Access Compliance Report

Public Rights-of-Way

Intersection ID: 10020377	Main Street: BALLANTYNE CORPORATE PL	Cross Street: N/A	Location: NW
ADA ID: 8C131049BC6E	Ramp Type: Perp	Initial Pass/Fail: Fail	Overall Compliance: No
Severity Score: 12.5			
Codes/Mitigation Info/Possible Solution		Field Measurements/Component Compliance

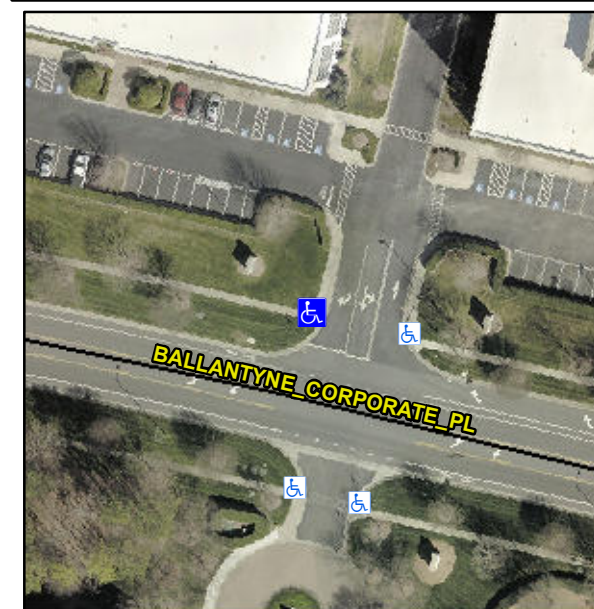
Not Found, R304.2.2

Compliance	Description	Data	Compliance	Description	Data
N/A	Ramp Length (in)	51.0	No	Ramp Slope (%)	10.5
Yes	Ramp Width (in)	48.0	Yes	Ramp XSlope (%)	1.0
N/A	Flare Type LT	N/A	N/A	Flare Type RT	N/A
N/A	Flare Slope LT (%)	N/A	N/A	Flare Slope RT (%)	N/A
N/A	Flare Traversable LT?	N/A	N/A	Flare Traversable RT?	N/A
N/A	Landing Length (in)	N/A	N/A	DWS Provided?	N/A
N/A	Landing Width (in)	N/A	N/A	DWS Contrast?	N/A
N/A	Landing Slope (%)	N/A	N/A	DWS Length (in)	N/A
N/A	Landing X Slope (%)	N/A	N/A	DWS Full Width?	N/A
N/A	Landing Curb? (Y/N)	N/A	N/A	DWS Offset (in)	N/A
N/A	Shared Landing?	N/A			
N/A	Gutter Ponding?	N/A	N/A	Gutter Slope (%)	N/A
N/A	Gutter Lip Ht (in)	N/A	N/A	Gutter X Slope (%)	N/A
N/A	Painted X Walk1?	No	N/A	Painted X Walk2?	N/A
	X Walk 1 Direction	To SE		X Walk 2 Direction	N/A
N/A	X Walk 1 Width (in)	N/A	N/A	X Walk 2 Width (in)	N/A
	X Walk 1 Slope (%)	1.5		X Walk 2 Slope (%)	N/A
	X Walk 1 X Slope (%)	2.9		X Walk 2 X Slope (%)	N/A

Remove & Replace Entire Ramp.
